**FINDINGS AND RECOMMENDATION  
OFFICE OF PLANNING AND ZONING  
ANNE ARUNDEL COUNTY, MARYLAND**

**CASE NUMBER:** 2024-0080-V

**REQUEST**

The applicants are requesting a variance to allow a dwelling addition (roof over patio) with new lot coverage nearer to the shoreline than the closest facade of the existing principal structure<sup>1</sup> on property located at 608 Overhill Drive in Edgewater.

LOCATION DRAWING OF:

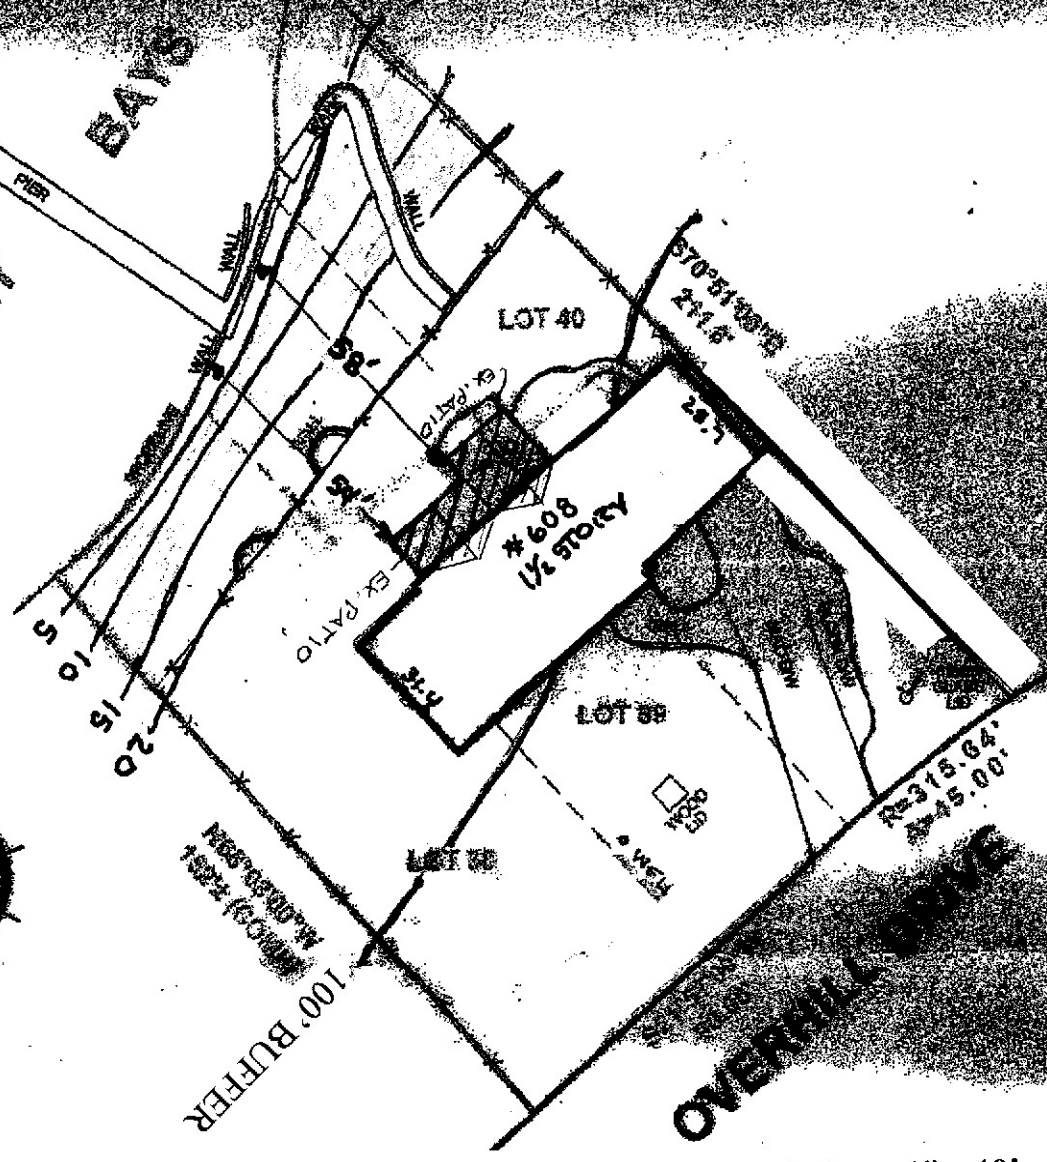
The **Development Division (Critical Area Team)** has no objection, provided that it is a roof structure only with no enclosures and it remains on or within the footprint of the existing patio.

The proposed roofed area with open sides located over the existing impervious patio is considered to be the minimum variance relief necessary to provide reasonable, protected use of the applicants' existing outdoor amenity area.

Based upon the standards set forth in § 18-16-305 of the Code under which a variance may be granted, this Office recommends ***approval*** of the proposed Critical Area variance to allow a dwelling addition (roof over patio) with 440 square feet of new critical area lot coverage nearer to the shoreline than the facade of the existing principal structure, as shown on the site plan submitted by the applicants. Any approval should be conditioned on the support posts being set in so that the proposed roof overhang does not extend beyond the edges of the existing patio.
